Change of External Appearance of DC Power Type Main Units, FX3S-10M and FX3S-14M

February 2021

FAM-A-0013-A

3 DETAILS ON THE CHANGE

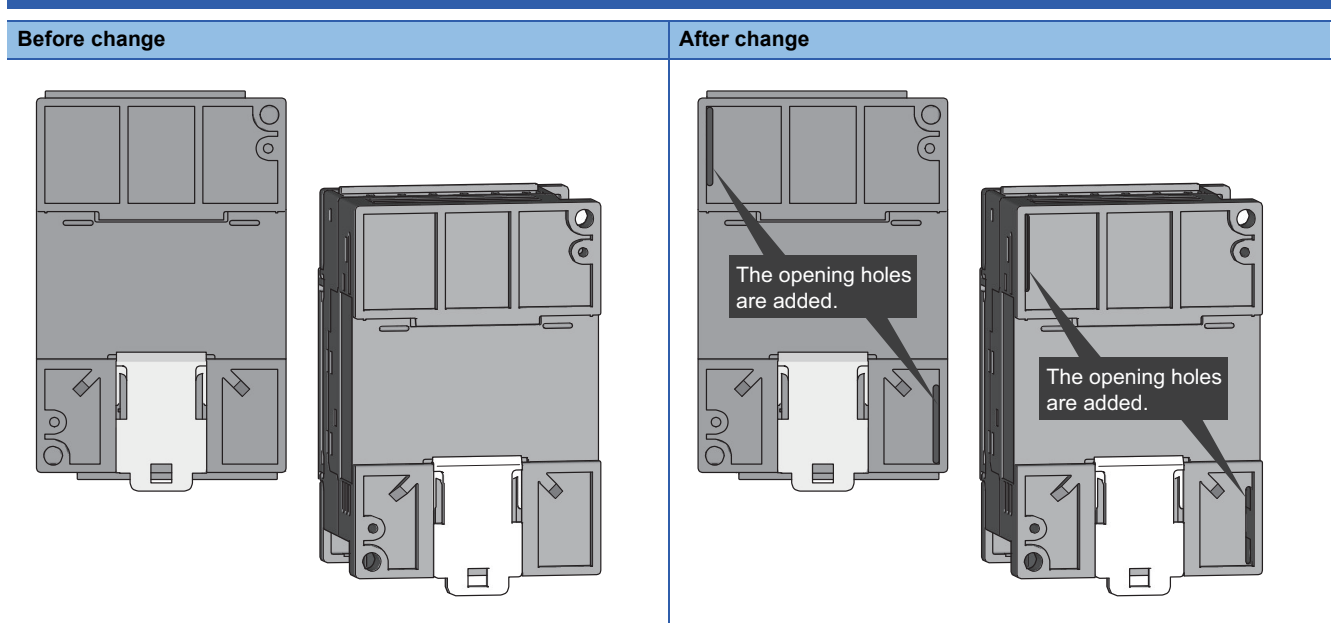
We are informing you that the external appearance of the DC type main units, MELSEC-F series FX3S-10M and FX3S-14M, will be changed.

There is no impact on the general specifications, performance specifications, and external dimensions of the units due to the change.

To make it easier to install/remove the unit.
